## Product Change Notice (PCN)

**PCN Number:** PCN-0381146R-02

Product(s) Affected: *CLS0261MAE-L152*

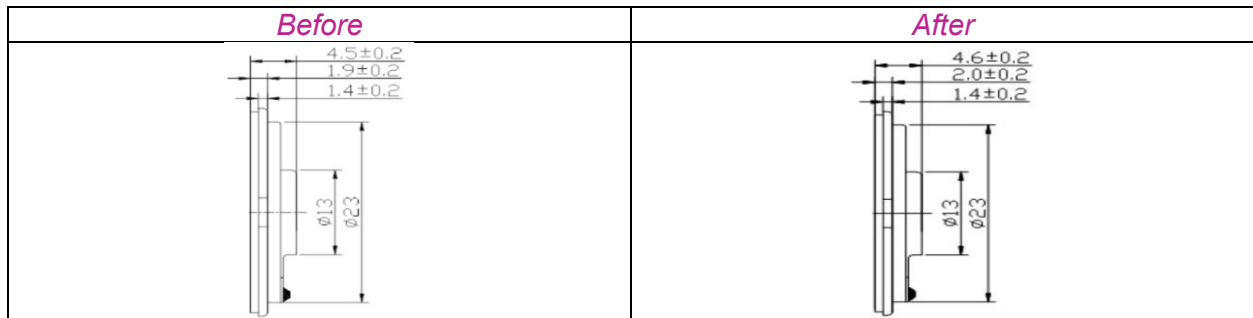
Reason(s) for Change: *Improved consistency in the appearance and flatness of the gasket.*

Description of Change: *Outer gasket updated from Paper to ABS for improved consistency in shape and flatness. The speaker height has increased by 0.1mm.*

Product Availability: *All goods with a date code of 2617 and later will have this ABS gasket*
